City of
Richmond

Report to Development Permit Panel

File: DP 22-023117

Re: **Application by Wayne Fougere for a Development Permit at
9511 Granville Avenue**

FLOOR PLANS BUILDING 4

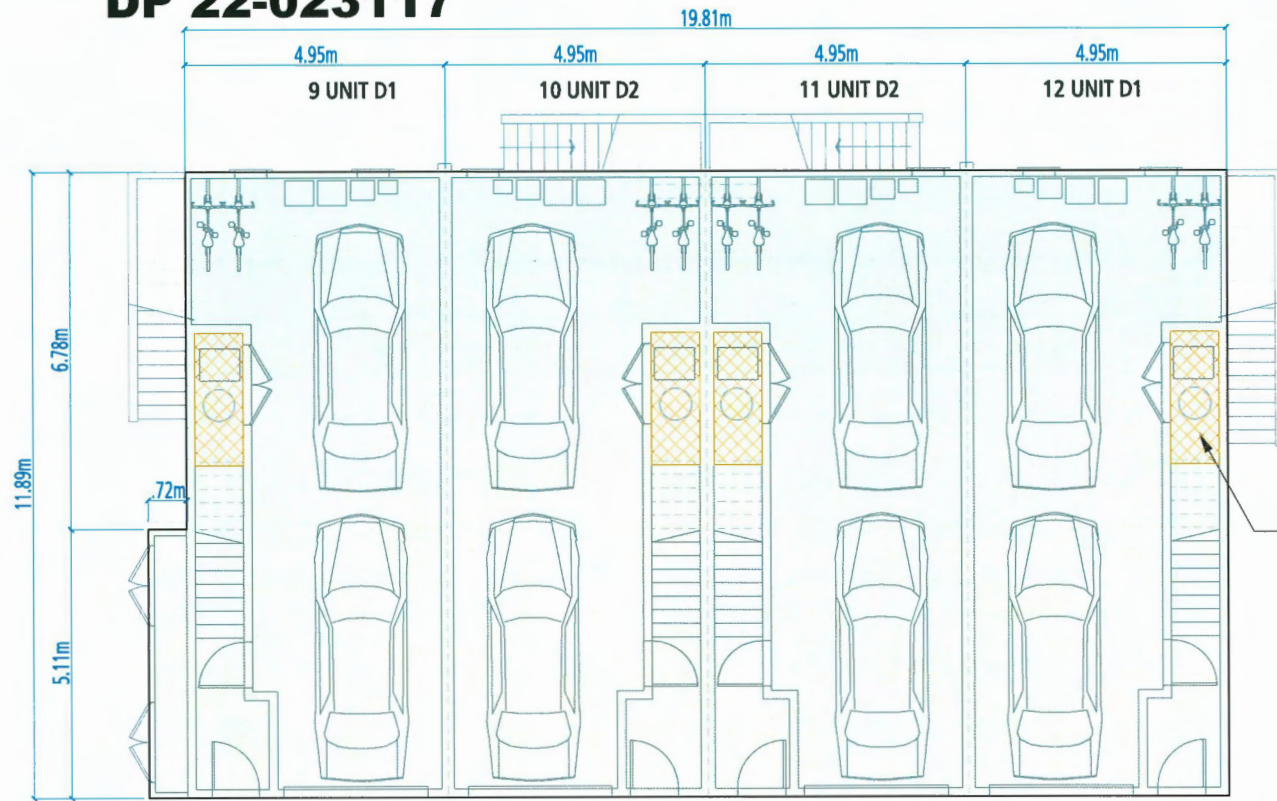
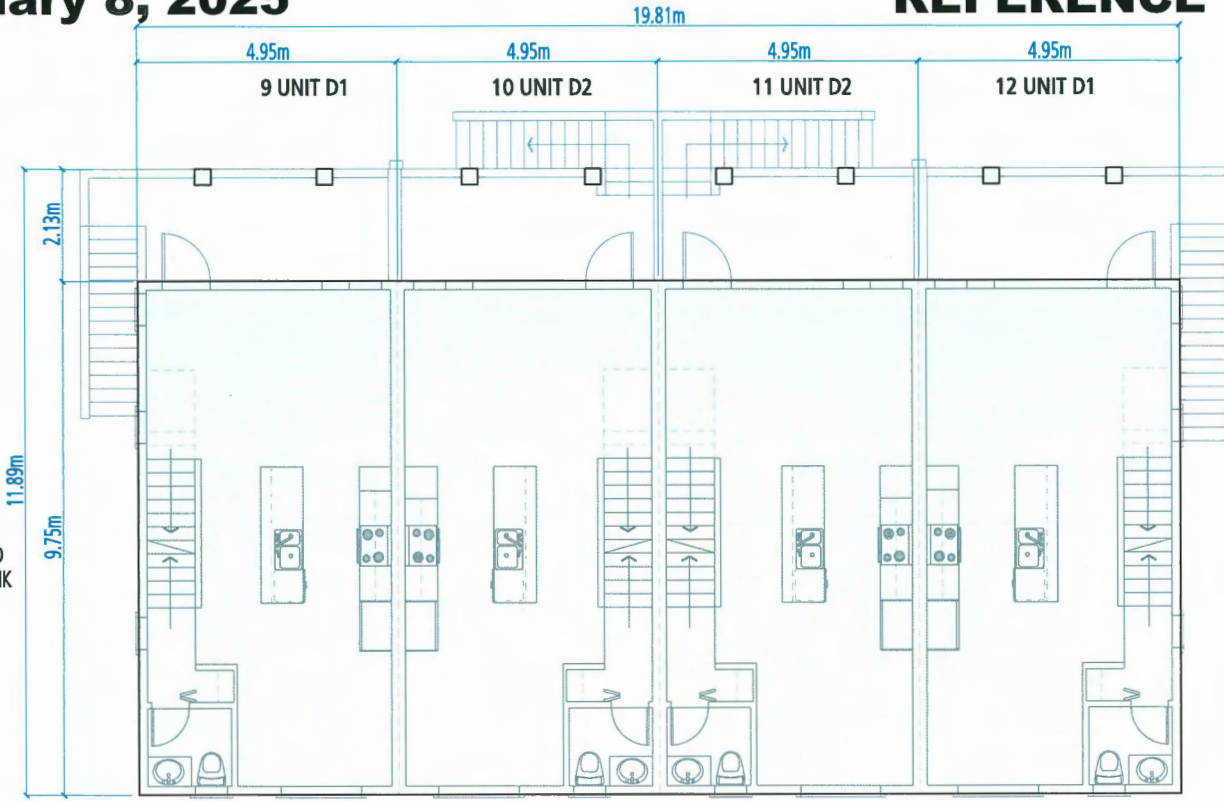
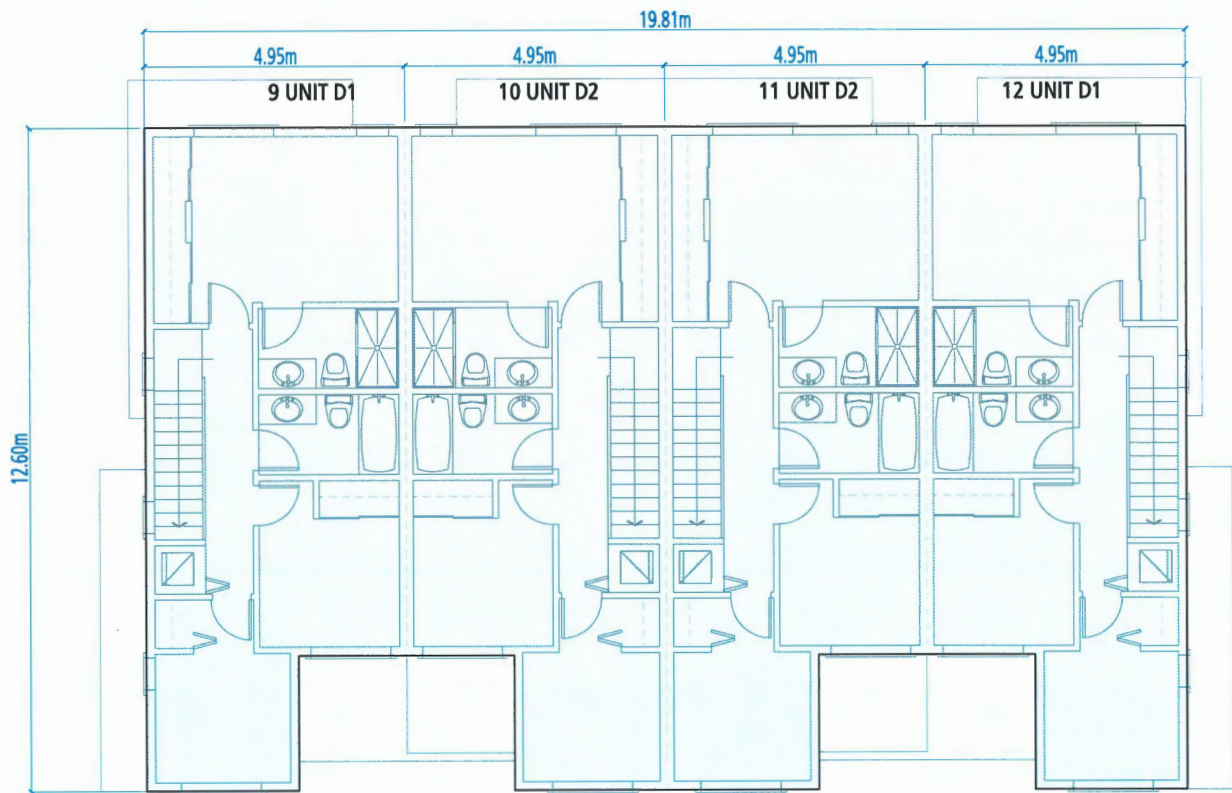
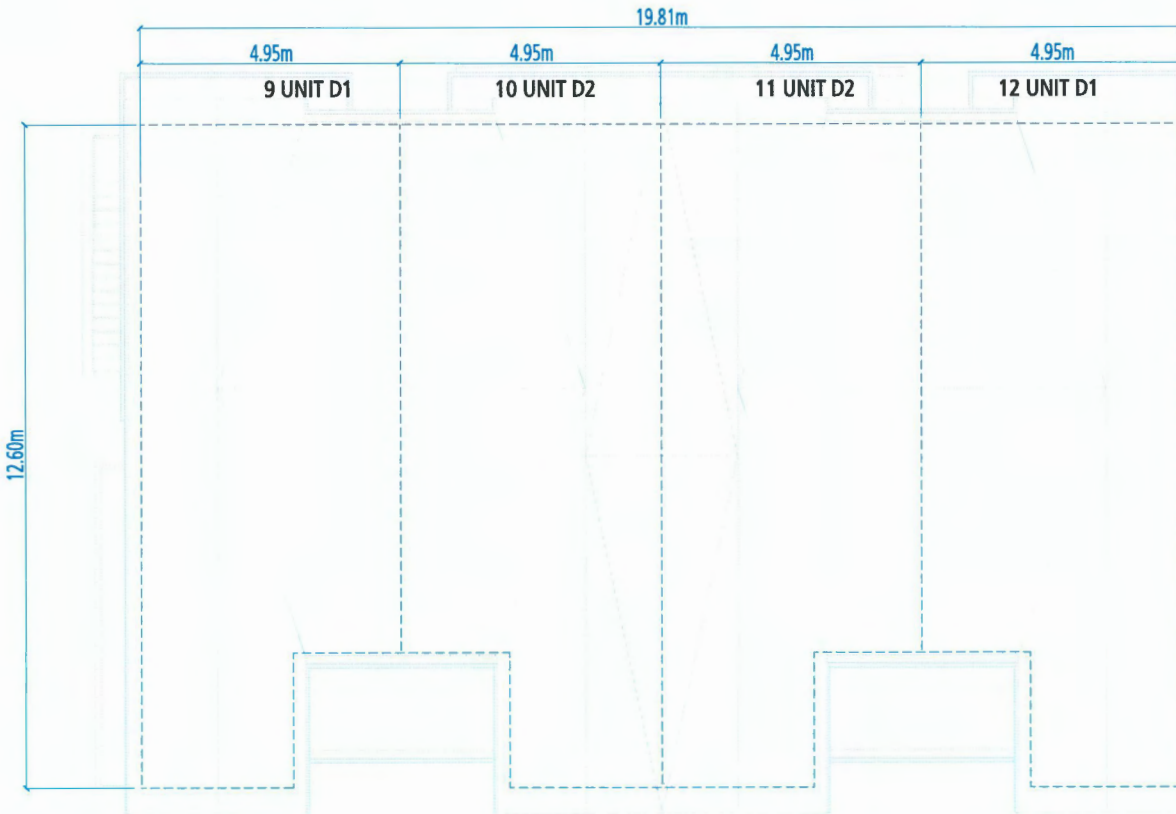
- concerned about the location of the van accessible parking stall (stall V3) in front of the entry door of Unit 12 of Building No. 4 as it may impact the access to the entry door of the unit, especially if the accessible van will be using a ramp; consider looking at ways to improve the sense of arrival for the unit, e.g. review the unit's floor plan and consider relocating the stairs to the interior wall side to help push the entry door away from the corner;
As noted in the first ADP comment above, this parking stall location gives adequate space for the aisle beside the parking.

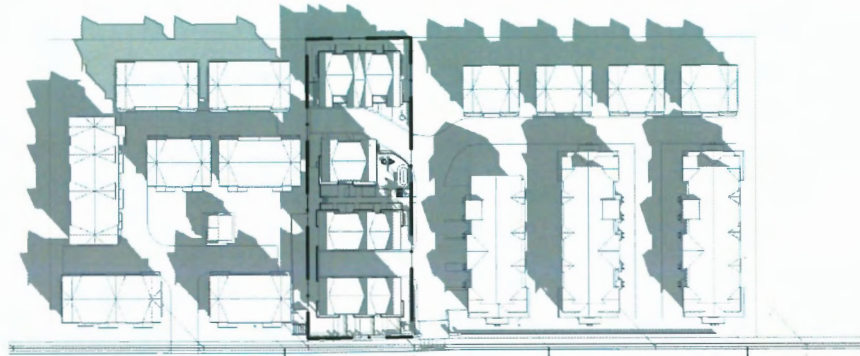
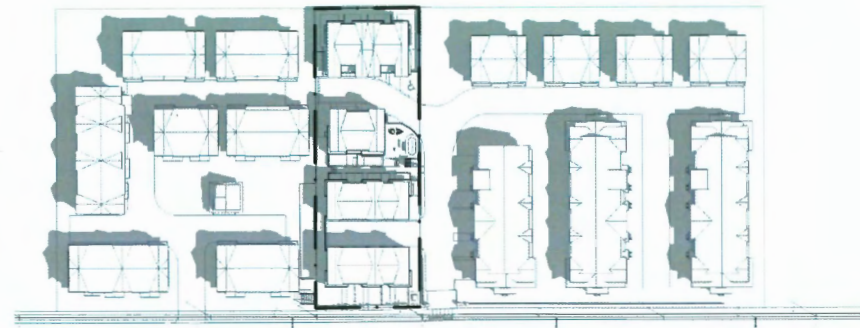
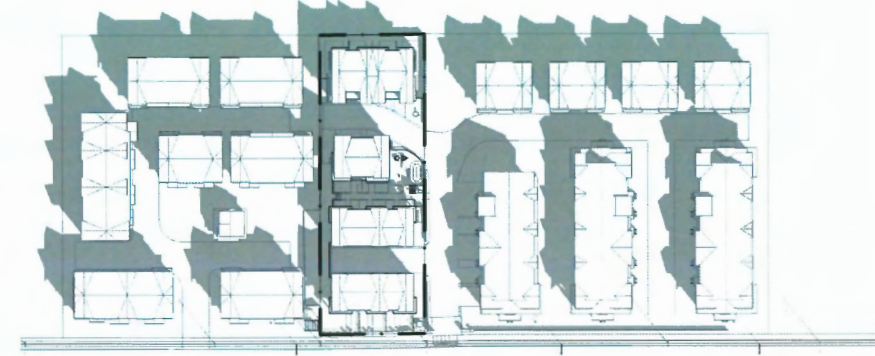
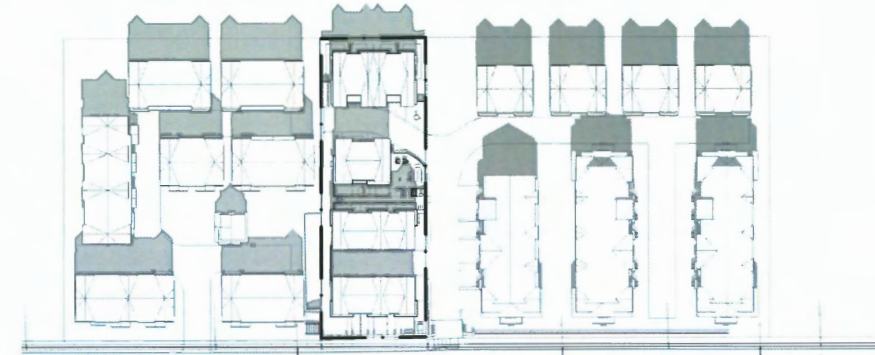
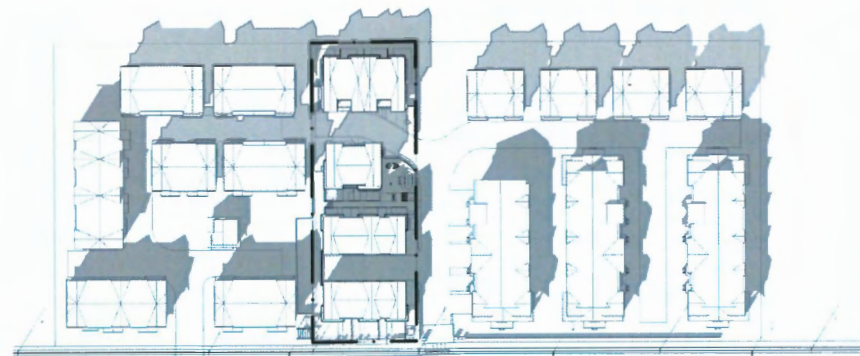
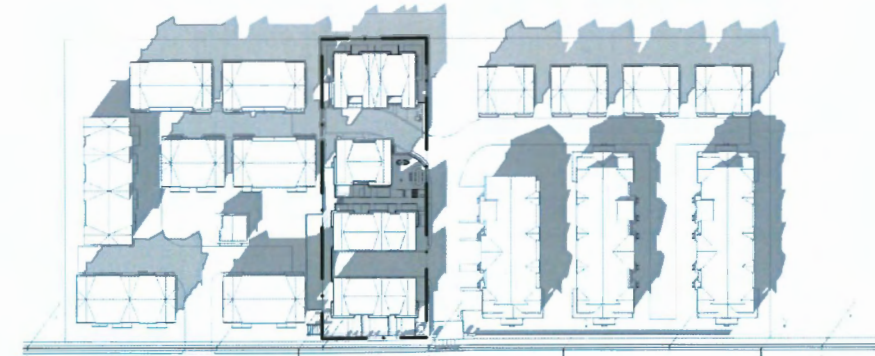
- the proposed central common walkway area will be in shade a lot of time as indicated in the shadow study; consider opportunities to enhance it as a central feature;
As the primary pedestrian access to five of the residential units, the central common walk is a vital part of the on-site circulation system. It is also a charming stroll lined by mixed hedge plantings and picket fences defining private gardens. Given the compact nature of this development, those private gardens are precious. In recognition of this, it is most appropriate that the central walk be designed for movement only and not as a place where other residents might linger or recreate. It is intended to solely serve the adjacent units.
